REMARKS/ARGUMENTS

Appl. No. 10/725,675
Amdt. Dated August 3, 2004
Reply to Office action of May 4, 2004

FIG. 1

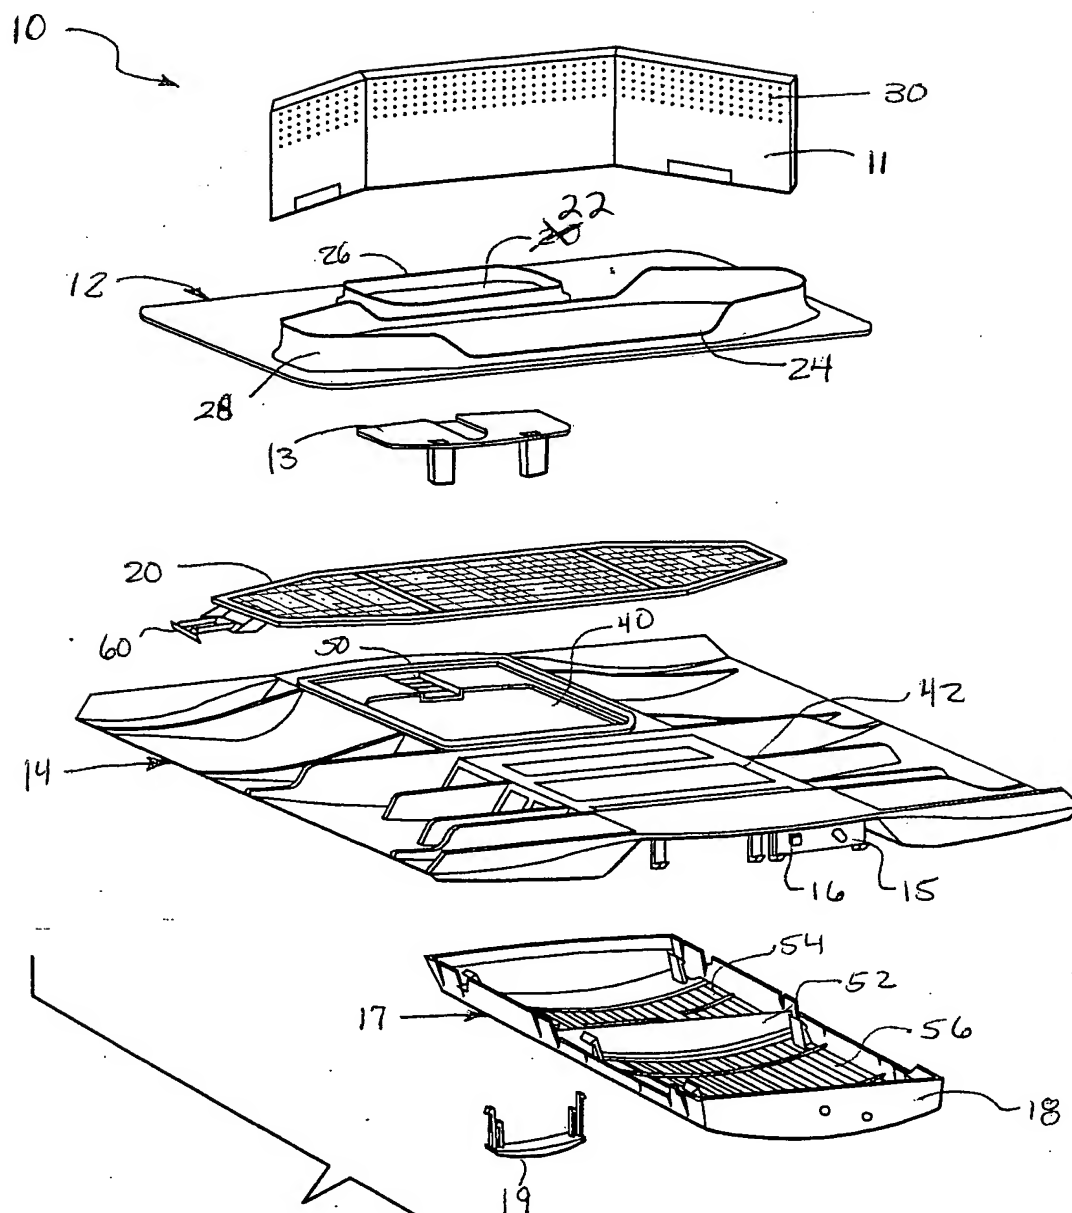
The Examiner further objects to the drawings as failing to comply with 37 CFR 1.84(p)(4) because reference character "22" [sic] has been used to designate two different parts. Applicant believes the Examiner intended to refer to character "20". As depicted in the annotated sheet showing changes, Applicant changed "20", associated with the ceiling template, to -22- in order to properly indicate the discharge opening and to provide agreement with the specification. The amendment to the drawings is believed to address the concern raised by the Examiner; accordingly, Applicant respectfully requests withdrawal of the corresponding objection to the drawings under 37 CFR 1.84(p)(4).
